# UNITED STATES PATENT AND TRADEMARK OFFICE

APPLICATION NO.	FILING DATE	FIRST NAMED INVENTOR	ATTORNEY DOCKET NO.	CONFIRMATION NO.
10/567,011	02/01/2006	Hirokazu Takashima	36856.1413	9487
54066 7590 05/04/2007 MURATA MANUFACTURING COMPANY, LTD. C/O KEATING & BENNETT, LLP 8180 GREENSBORO DRIVE SUITE 850 MCLEAN, VA 22102			EXAMINER THOMAS, ERIC W	
			ART UNIT 2831	PAPER NUMBER
			NOTIFICATION DATE 05/04/2007	DELIVERY MODE ELECTRONIC

## Office Action Summary

【図9】

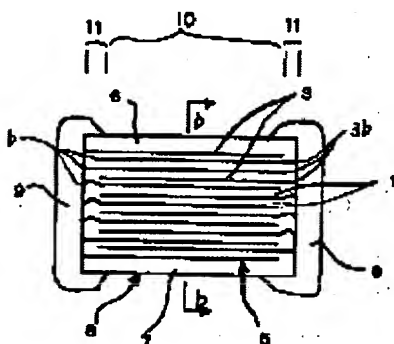
2. Claims 10, 16-18 are rejected under 35 U.S.C. 102(b) as being anticipated by JP 2001-155959 ('959).

'959 discloses in fig. 9-12, a multilayer ceramic capacitor comprising:

a main body having first and second main surfaces and four side surfaces connecting the first and second main surfaces to each other, a plurality of dielectric layers (1), at least one pair of first and second internal electrodes (3) between the dielectric layers and opposed to each other so as to generate an electrostatic capacitance; and first and second external terminal electrodes (9) arranged on an external surface of the main body so as to be electrically connected to the first and second internal electrodes, respectively; wherein

each of the first and second internal electrodes has a capacitance generating portion arranged to generate the electrostatic capacitance, a terminal connecting portion connected to the external terminal electrode (portion close to the external electrode), and an extended portion connecting the capacitance generating portion to the terminal connecting portion; and

the extended portion of at least one of the internal electrodes is curved in the direction of its thickness (see fig. 9).
